**City of Fairhope
Planning Commission Agenda
5:00 PM
Council Chambers
March 4, 2024**

1. Call to Order
2. Approval of Minutes
 - February 5, 2024
3. Old/New Business
 - **SD 22.05** Battles Trace Ph. 8 – Request of Applicant, Goodwyn Mills Cawood, LLC, for an extension of six months for preliminary plat approval.

SD 24.05 - The Proper

NICHOLS & YOUNG TOWNHOMES
PRELIMINARY PLAT

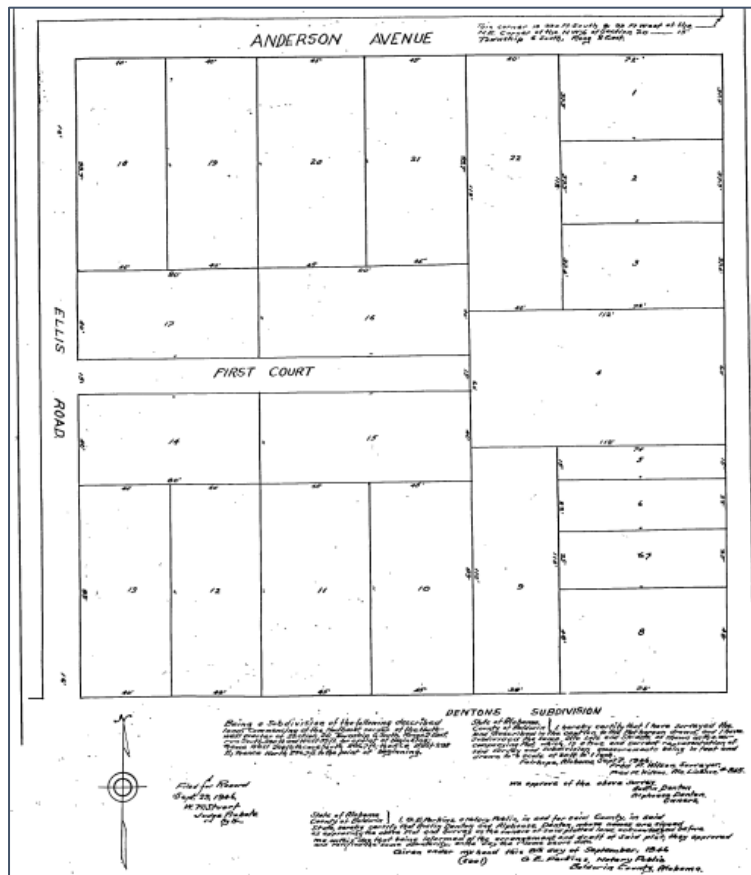
The City nor the County recall ever maintaining Anderson Avenue; thus, is Anderson Avenue a “paved, publicly maintained street” per the Subdivision Regulations? The City nor the County has conclusive evidence of the annexation or vacation of Anderson Avenue. County ROW confirmed a 15 ft ROW from a better version of Slide 116-A. Applicant contends that Anderson Avenue has a 20 ft ROW. Baldwin County Parcel Viewer has Anderson Avenue with 16 ft ROW. *See below.* [Baldwin County ISV3 \(kcsGIS.com\)](https://kcsGIS.com) last visited on February 23, 2024.

Slide 116-A has Anderson Avenue platted going all the way through to another unopened ROW Ellis Road. See below.

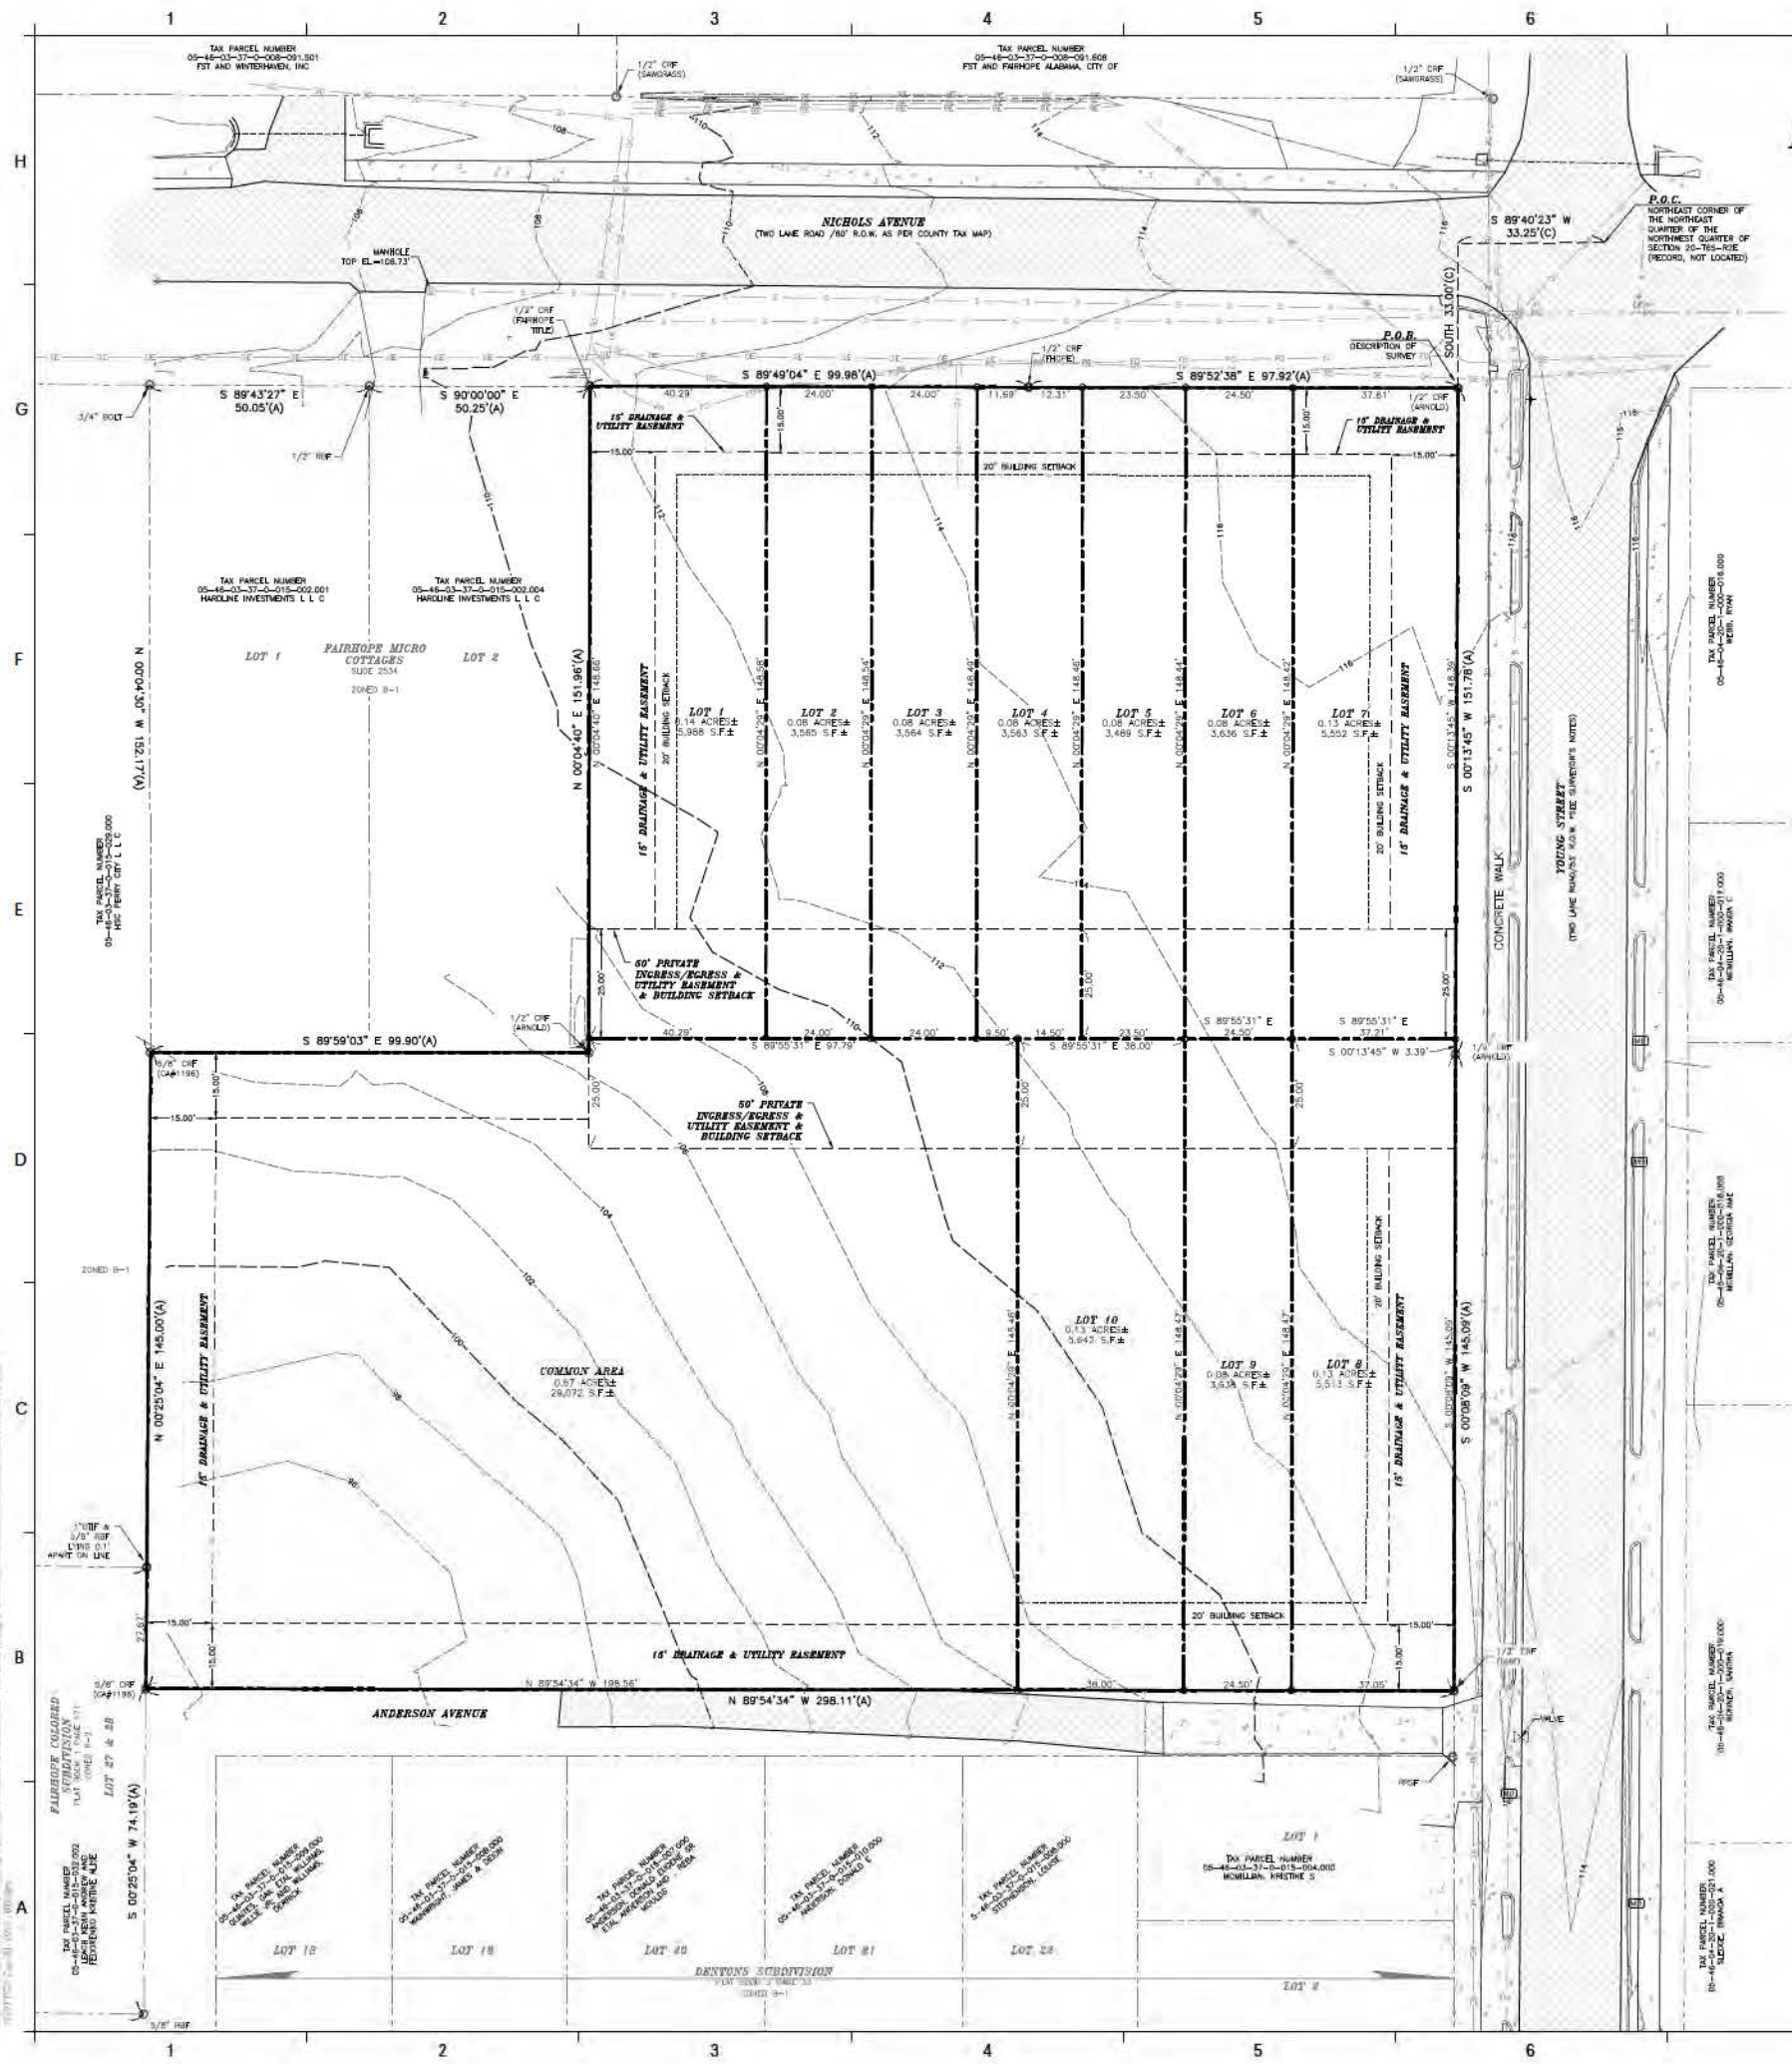
1. **A re-plat will be a condition of the MOP, if approved.**
 - a. *Acknowledged. A final plat will be submitted with future applications.*
2. **Need Conflict Resolution Plan that shows utilities (existing and proposed), overstory trees and power lines, building footprints, roads (private and public), and easements. All the layers need to be applied to one (1) sheet and colored to discern conflicts and solutions thereof.**

- a. *Revised landscape plans are included and reflect the requested changes. A Conflict Resolution Plan has been added.*
3. **Contact Horticulture Supervisor, Jamie Rollins (Jamie.rollins@fairhopeal.gov) for suggestions about shorter mature trees that may be used. The Horticulture Supervisor shall approve the final Landscape Plan.**

- a. *Acknowledged. We have coordinated with the Horticulture Supervisor for input and the revised plans follow the guidance provided.*
4. **Anderson Avenue:** City Engineer to follow up with Baldwin County about history and current classification of Anderson Avenue. It may be determined that the City needs an easement on each side. TBD.

6. Confirm with the Electric Department there needs to be a 5-6 ft circumference easement around concrete power pole on corner of Young Street and Nichols Avenue. Marshall King (marshall.king@fairhopeal.gov).
 - a. *The plans have been revised to reflect this easement. The pole and easement lie within the existing right-of-way.*
7. Water and Sewer needs to be located within the ROW and not on private property.
 - a. *The water and sewer mains have been relocated inside the right-of-way and plans revised accordingly.*
8. For stubbed out porches continue easement to sidewalk that connects to the streets.
 - a. *As was discussed at the plans review meeting, sidewalks have been extended to meet the existing pavement along Anderson Avenue.*
